RE: **Blythe Solar Power Project, Docket No. 09-AFC-6**
Responses to January 14, 2010 CEC Workshop Queries
Technical Areas:
Soil & Water Resources (supplemental data for DR-S&W-218)

**Soil and Water Resources
(Supplemental Data for DR-S&W-218)**

Blythe Solar Power Project
Docket No. 09-AFC-6

Soil and Water Data Responses to January 14, 2010 CEC Workshop Queries

Typical Details – CD-021

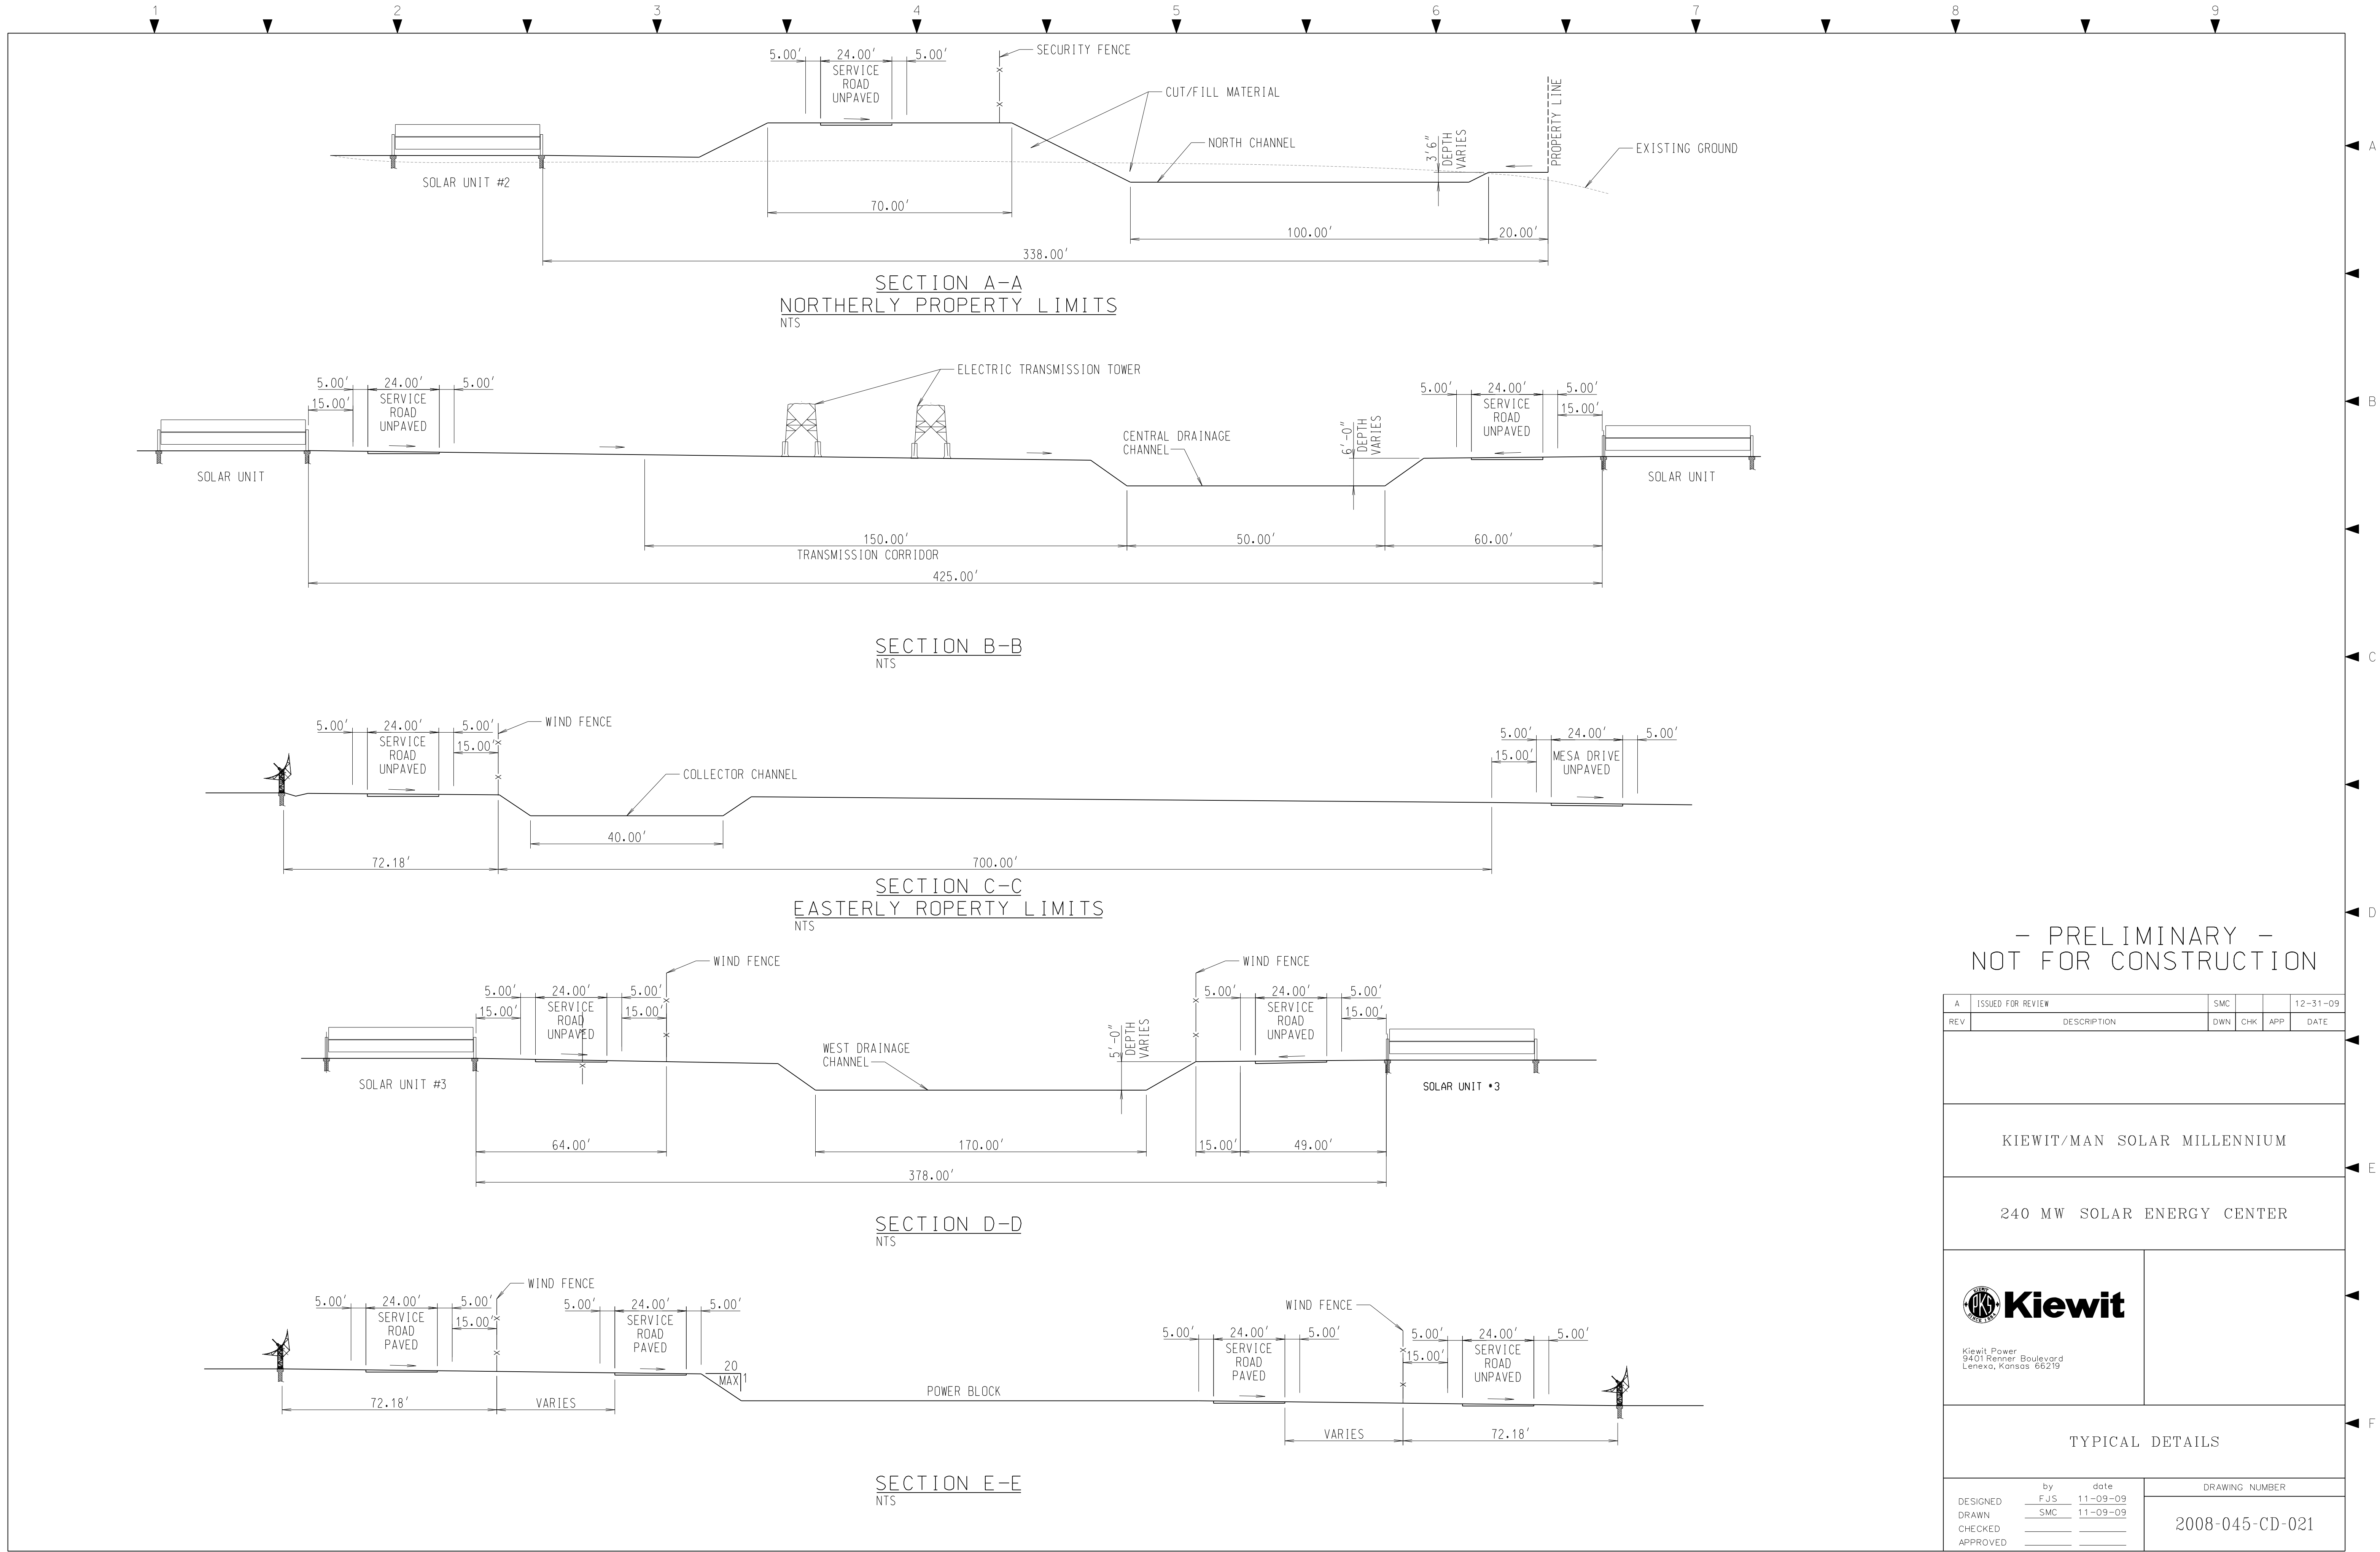
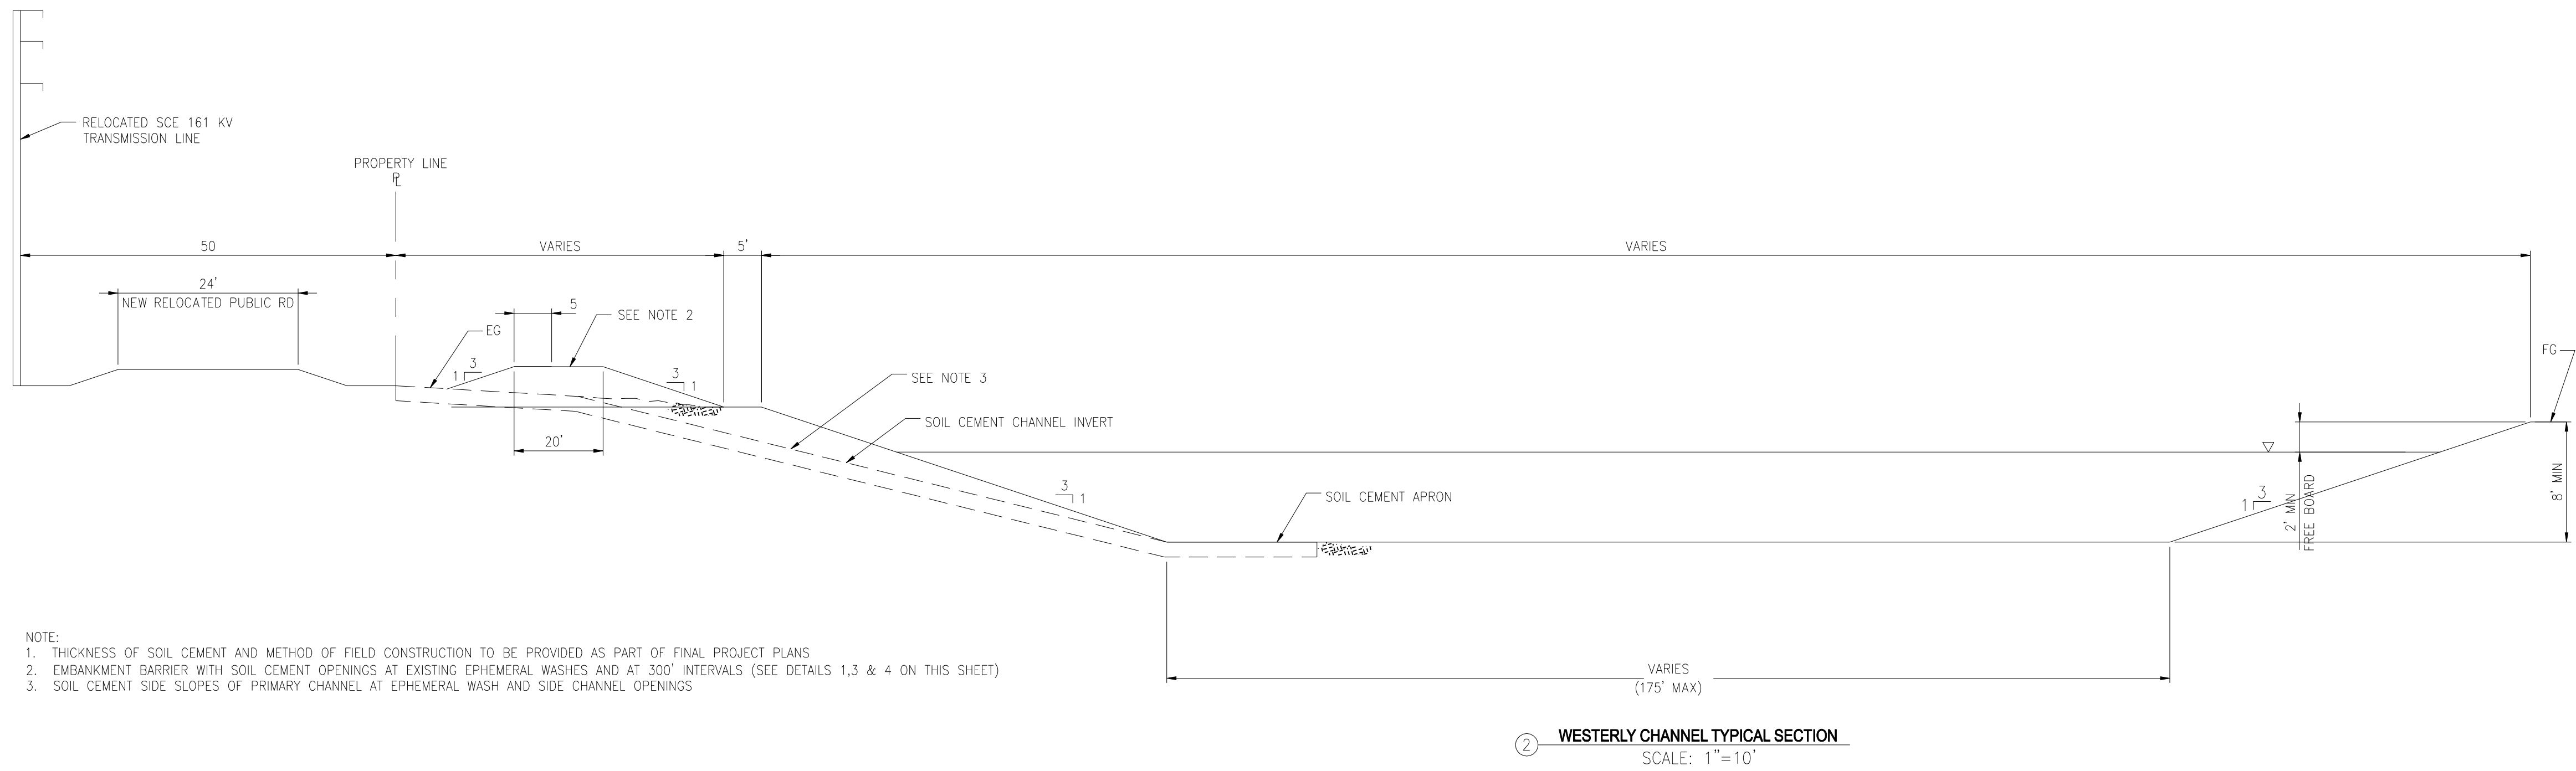
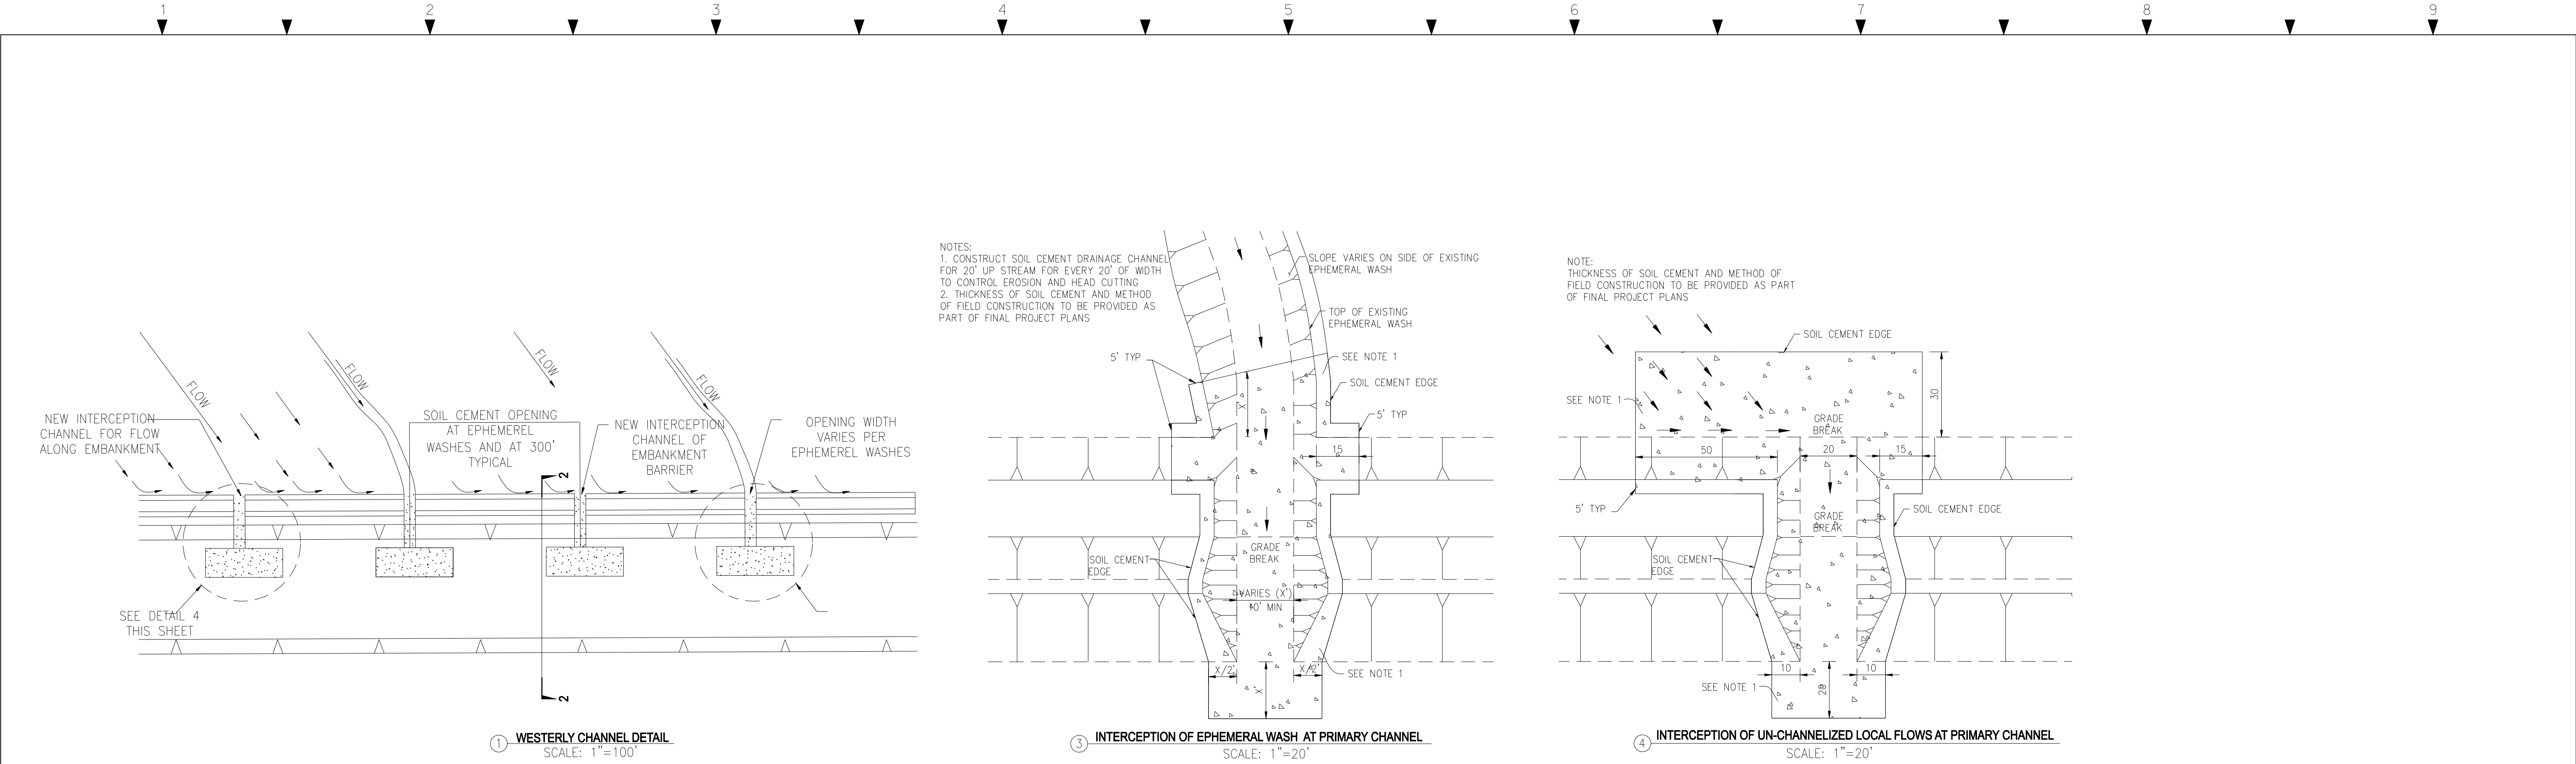
For response to DR-S&W-218, provide fuller explanation of relationship of cut slopes to berms and how water will be managed to avoid headcutting. For the main channels, provide greater level of detail on drawings to indicate relationship of cut slopes to berms and channels. Provide section drawings that show gaps in berms to allow water passage from upslope areas.

The issue of headcutting of channels upstream of the site will be precluded primarily by use of soil cement where existing and proposed channels enter into the primary offsite channels and by use of small (20 foot wide and 2.5 feet high) embankments placed upstream of the primary channel to direct existing drainage flows as well as future flows that may migrate into specific localized drainage inlets to the primary off-site drainage channels.

In essence, the small embankment is placed immediately upstream (5 feet away) from the upstream face of all perimeter channels that receive off site flows. This embankment runs the entire length of the perimeter channel. This embankment is then opened up at all locations where it is intercepted by off site ephemeral channels. The opening is constructed at the same current width as the existing ephemeral channel. The drainage path is then carried over the face and down the slope of the primary drainage in a defined "side slope" down-drain. Soil cement is placed within the ephemeral channel upstream of the embankment, through the opening in the embankment, along the full extent of the "side slope" down-drain, and out into the channel with an apron structure. Soil cement is also placed along the faces of the embankment on the upstream and downstream edges to preclude erosion and loss of embankment slope.

Additional details have been provided as part of this response that show this embankment barrier and the interception channels; how they operate, and how they are protected with soil cement, which in turn precludes head-cutting. This detail is shown on the detail sheets CD-021 to 024 of the revised plans.
